Calderwood Urban Development Project

Section 75W Application

Water Cycle and Flood Management
Strategy Updates

Post-Exhibition Report

Figure 8.08
Calderwood Urban Development Project

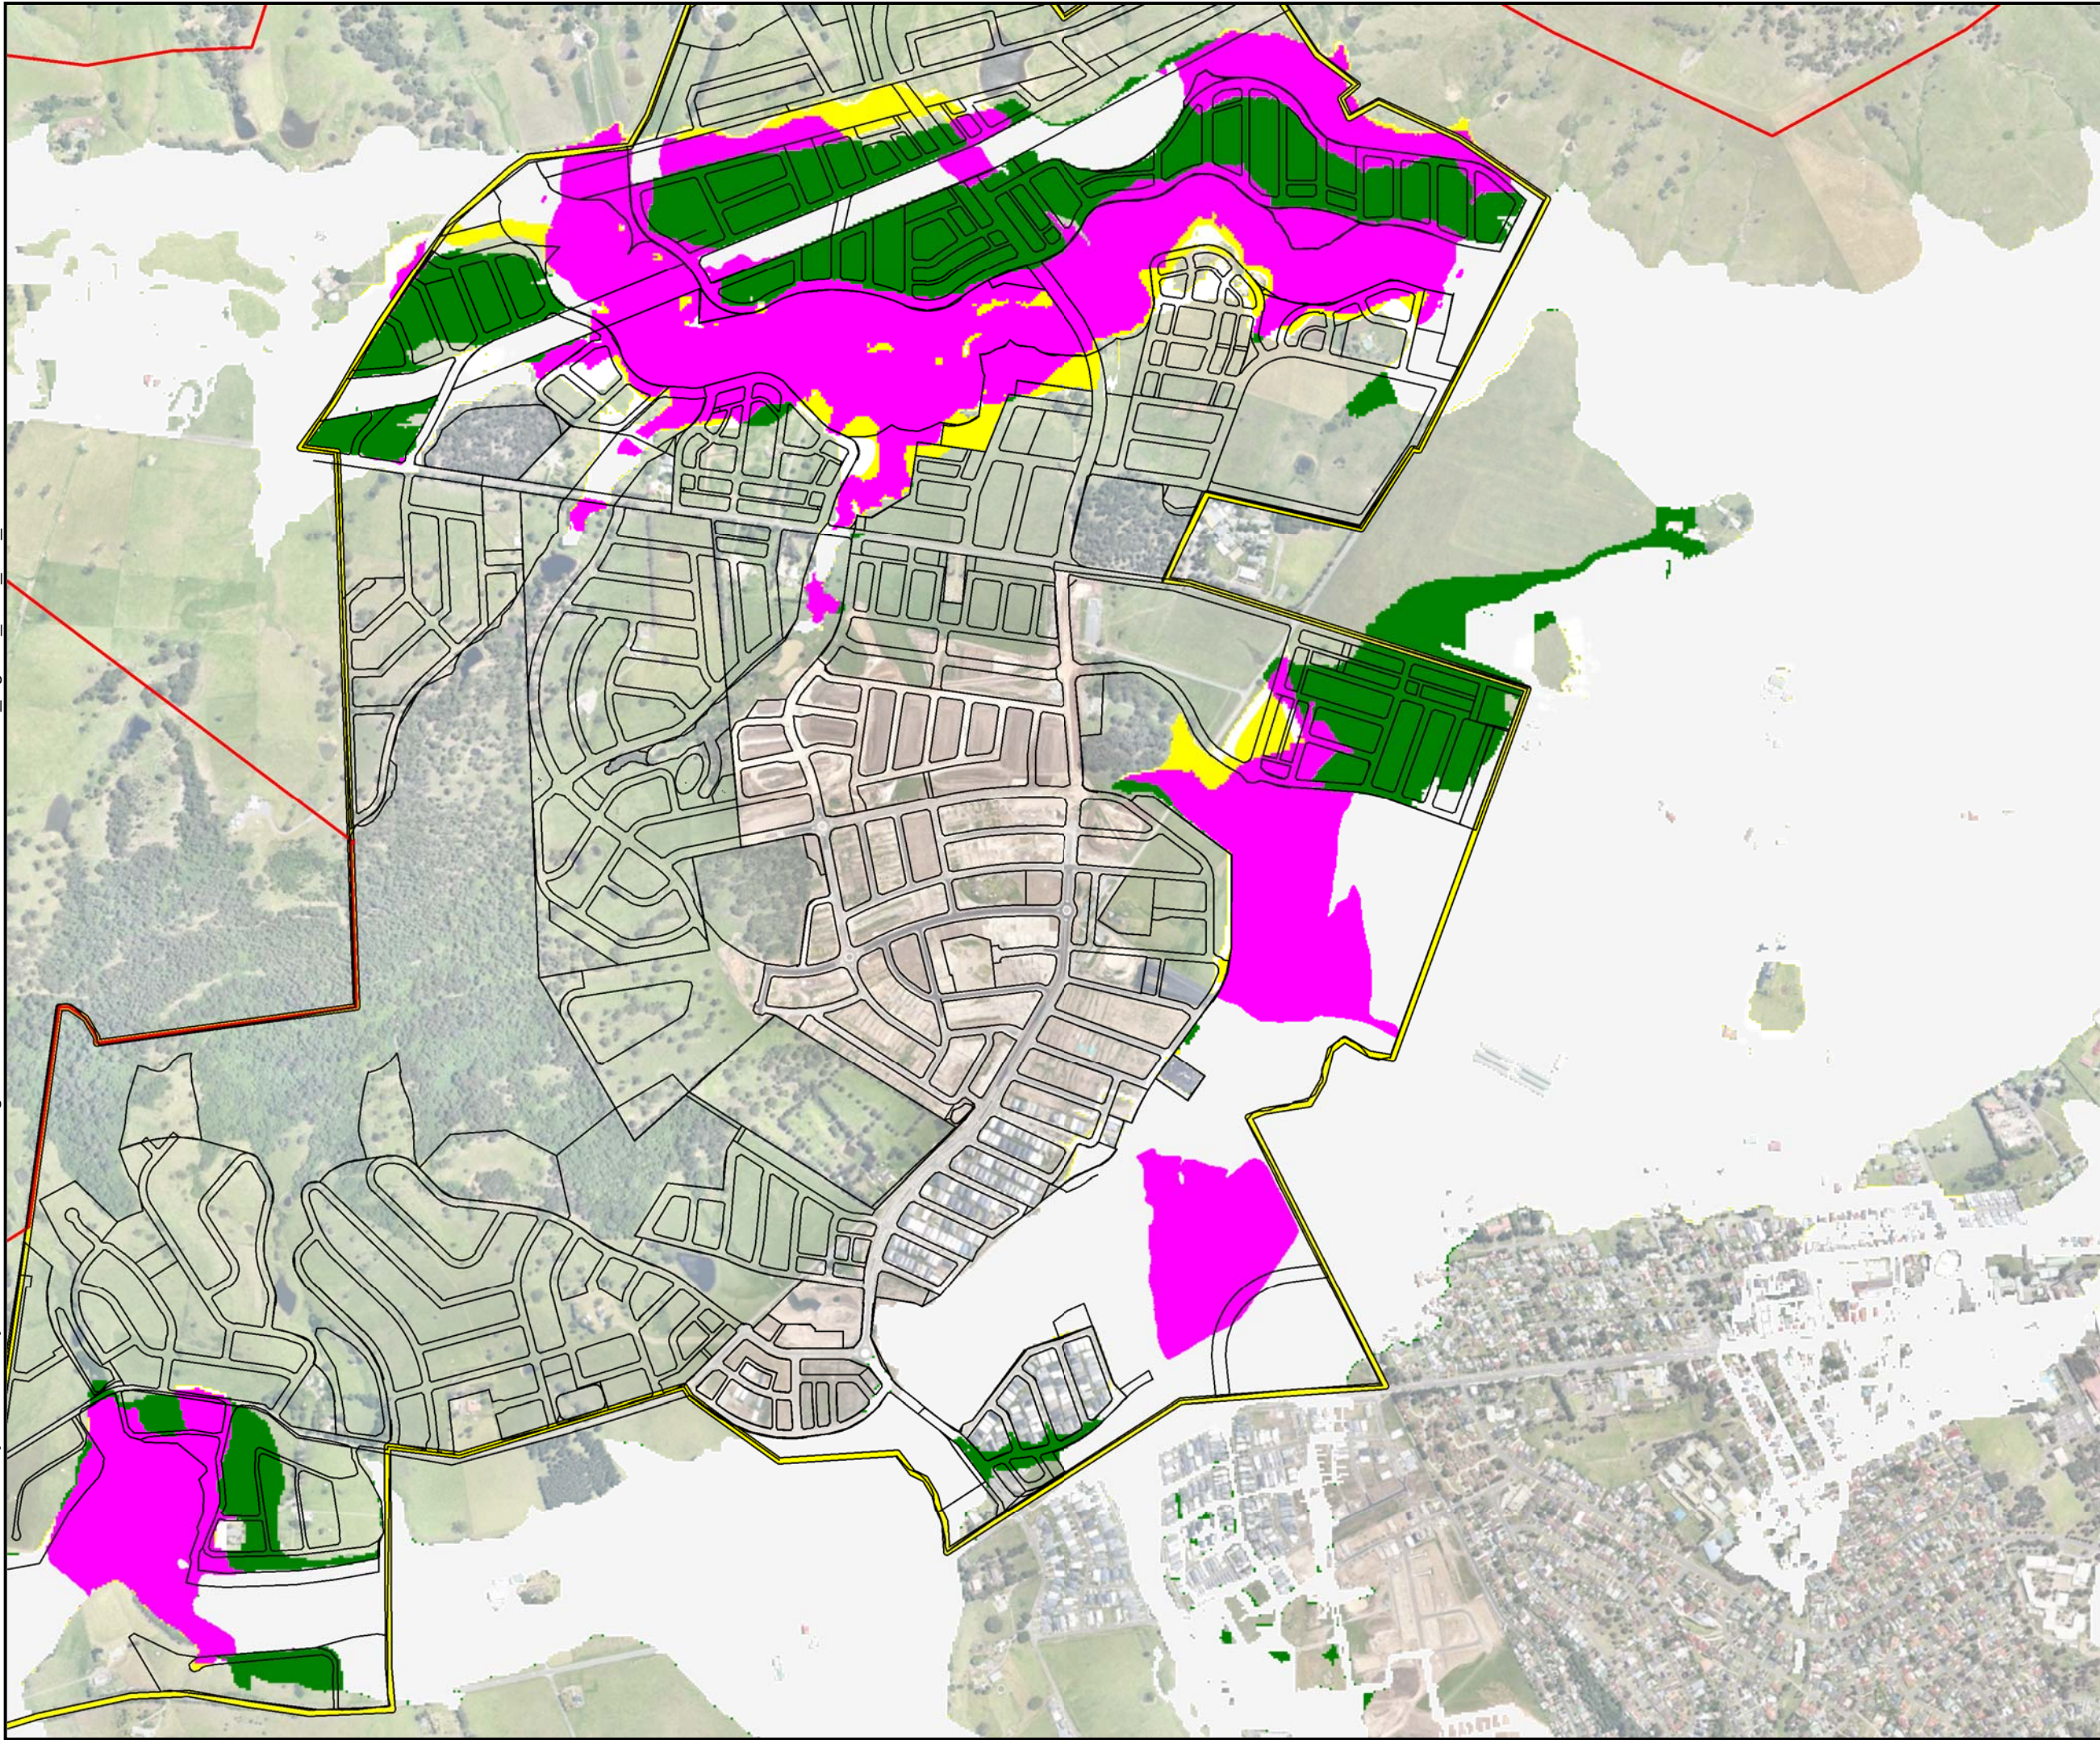
Figures 8 and 13 of the report indicate significant increased flood affectation (>0.4m) downslope of the CUDP for both the 1% AEP and PMF events, with no explanation on how these impacts will be managed. This is contrary to Item 11 of the SEARS report.

Flood affectation downstream of CUDP for both 1% and PMF events is consistent with the original concept approval that indicated that flood impacts downstream of the site are between 0.02 – 0.2 m. Flood affectation in PMF downstream of CUDP is illustrated in Figure 8.08 of the WCFM strategy and complies with the MOD 3 Terms of approval for the Stage 1 Project application: Part B of Condition B26.1, which states to “minimise off-site impacts in the PMF event such that the maximum increase does not exceed 0.3 m”.

Figure 8.05 and Figure 8.08 provide the 1% AEP, and PMF flood differences maps are provided within the WCFM strategy report. As there is no requirement for lots to be above the PMF, provision of flood affectation maps above the flood planning level is not necessary.

Figure 8.08 demonstrates that PMF impacts are less than 0.3m and consistent with Condition B2.6.1 of the court approval for Stage 1.

PLAN No:
Figure 8.10

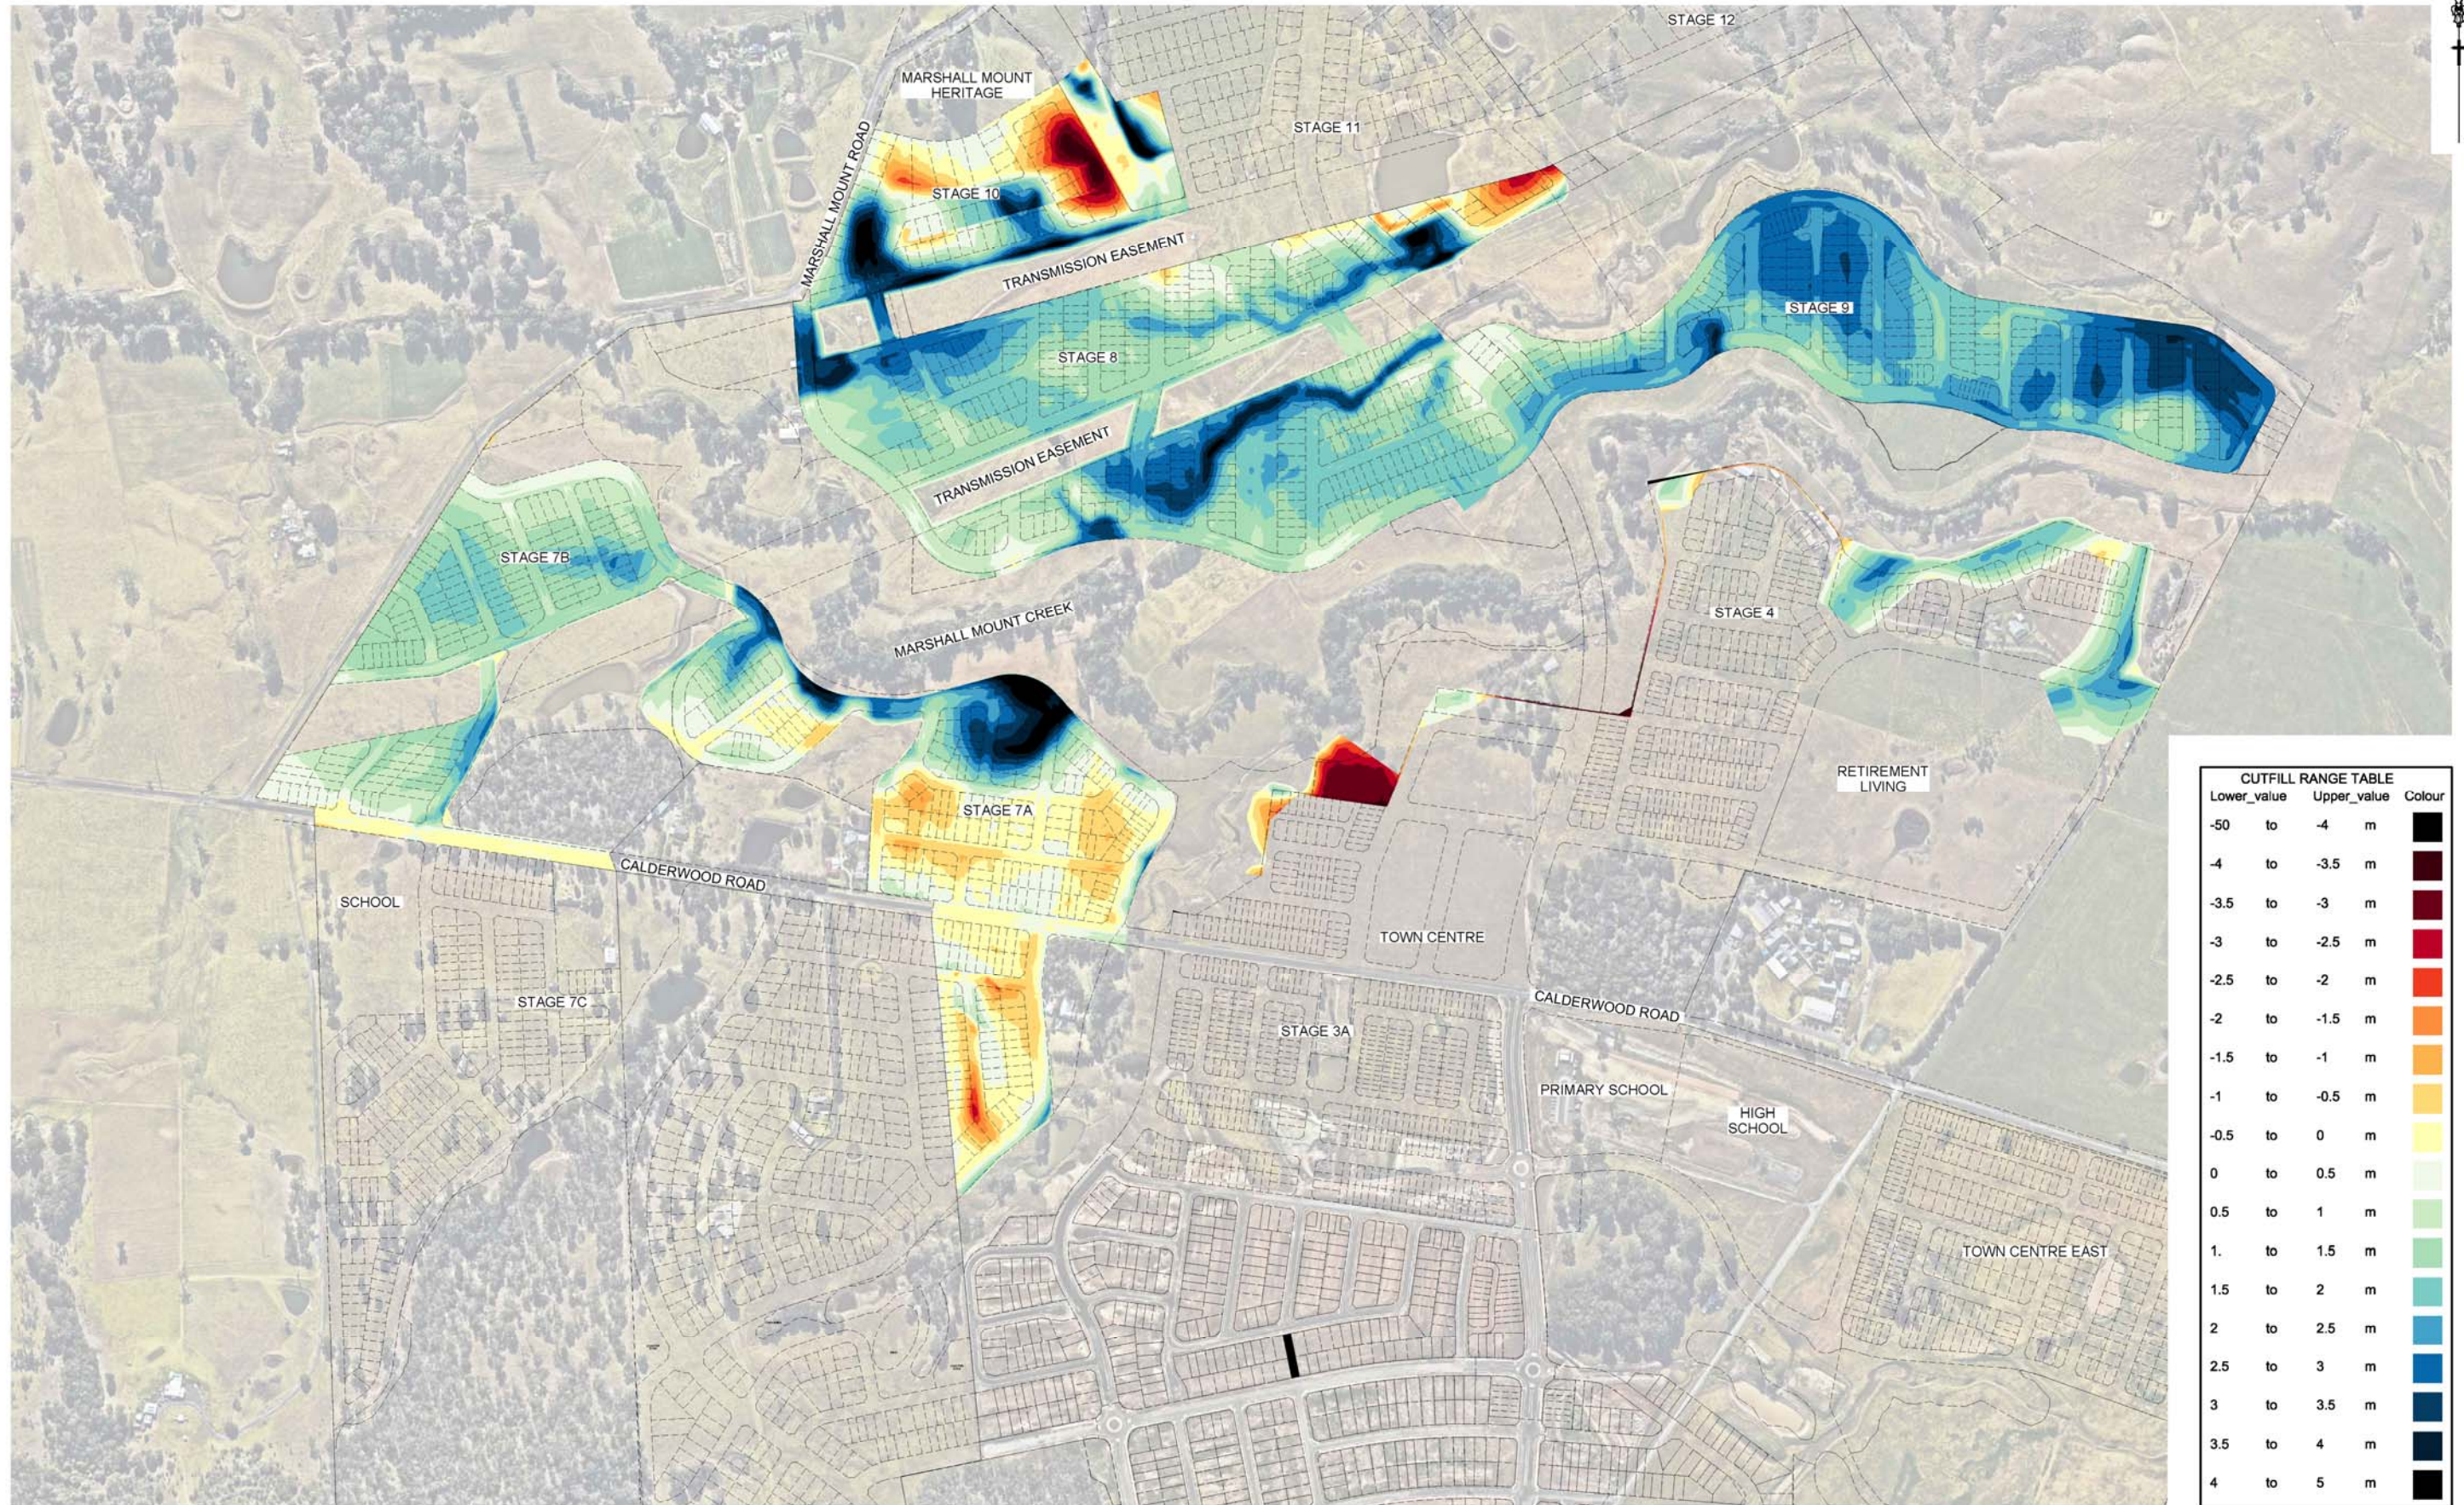
Figure 3 of the report indicates areas of proposed cut and fill across the site, however does not indicate the maximum depths of cut/fill. In this respect, it is unclear whether the proposal satisfies item 9 of the SEARS relating to potential visual impacts associated with the amount of cut/fill proposed.

A comprehensive landscape/restoration plan will form part of the future DA for WCC’s consideration. A cut and fill plan has been provided as part of the revised WCFM which indicates locations and depths of the proposed cut and fill. Refer to Figure 8.10 for details. Any visual impacts of the proposed cut/fill will be addressed as part of future DA assessments.

A cut and fill plan has been provided as part of the Post Exhibition WCFM which indicates locations and depths of the proposed cut and fill. Refer to Figure 8.10 for details.
